APPLICATION FOR WITHHOLDING PROPRIETARY
INFORMATION FROM PUBLIC DISCLOSURE

Subject: Caldon ER-157P, "Engineering Report – 157P: Supplement to Topical Report ER-80P: Basis for a Power Uprate With the LEFM[✓]™ or LEFM CheckPlus™ System", Rev. 2 enclosure – FENOC Letter, L-01-006, "License Amendment Request Nos. 289 and 161"

Beaver Valley Power Station, Unit No. 1
License Amendment Request No. 289

FIGURE 3.4-2
Beaver Valley Unit 2 Reactor Coolant System Heatup
Limitations Applicable for the First 15 EFPY

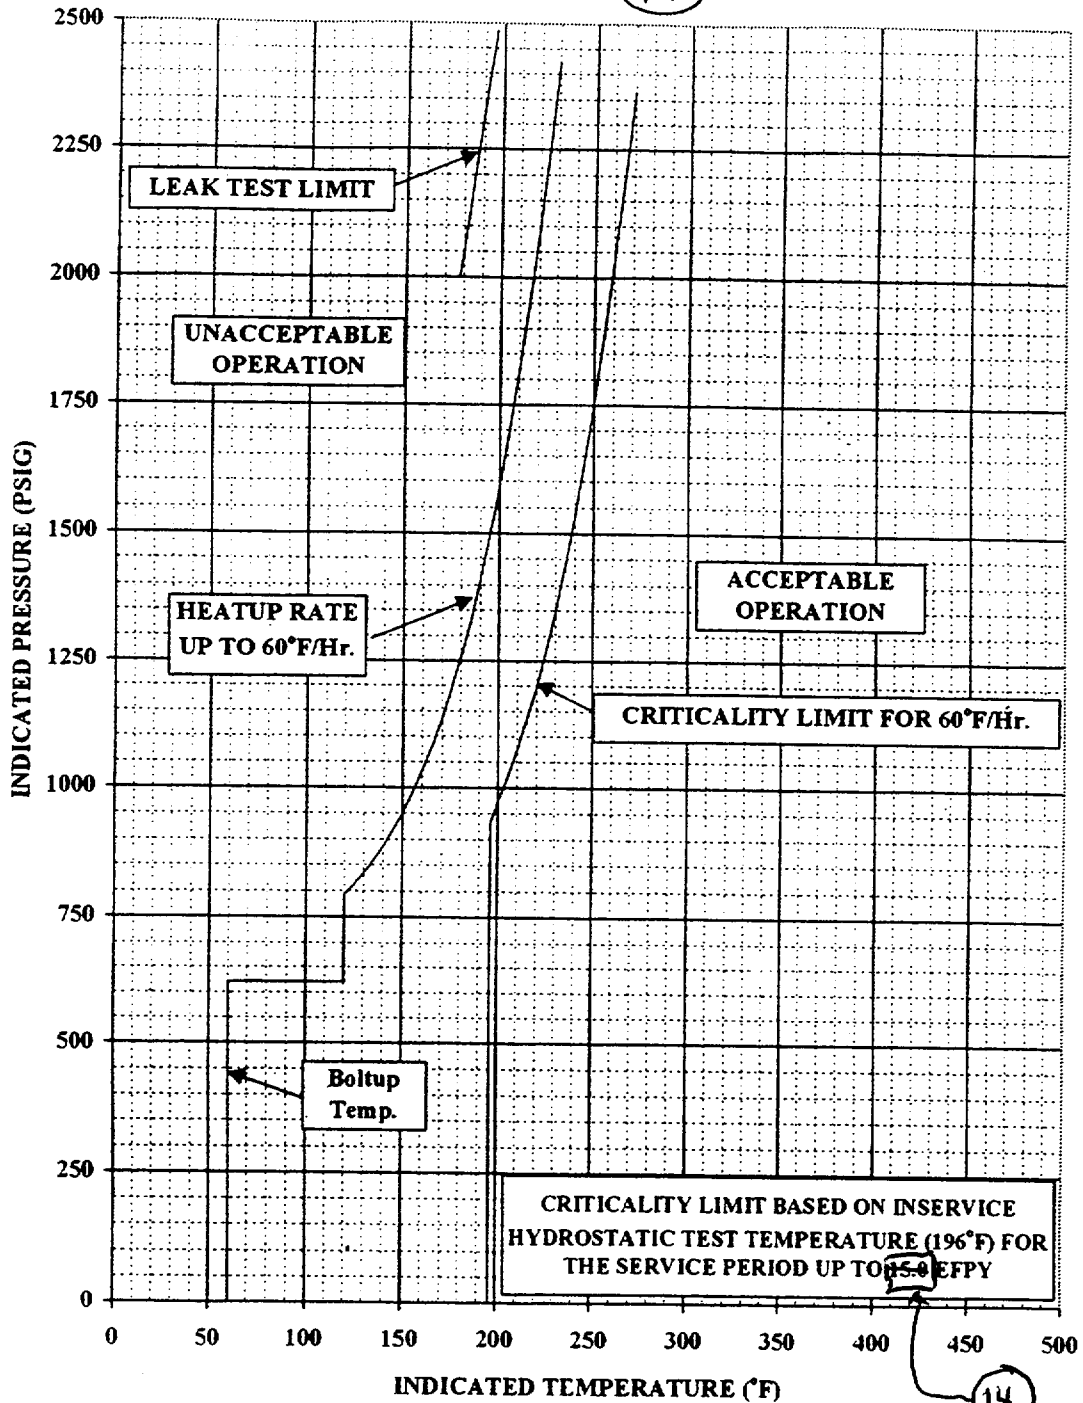
The Unit 2 reactor coolant system heatup/cooldown curves contained in Figures 3.4-2 and 3.4-3 of TS 3.4.9.1 are revised to reflect a reduction in applicability of the current limits from 15 to 14 EFPY. This is due to the increased neutron fluence associated with the proposed increased power level. Similarly, Bases page B 3/4 4-7 is also revised to reflect the reduced applicability. This change is supported by evaluations provided in Section 3.6.2.2 of Enclosure 1. Unit 2 is currently at approximately 10 EFPY, so this will not impose limitations on operations in the near term.

- Unit 2 TS 3/4.4.9, "Pressure/Temperature Limits" contain heatup/cooldown curves, i.e., Figures 3.4-2 and 3.4-3 (sheets 1-5). These curves are being revised from 15 Effective Full Power Years (EFPY) to 14 EFPY. The applicable Bases pages are also revised to reflect the change in EFPY.
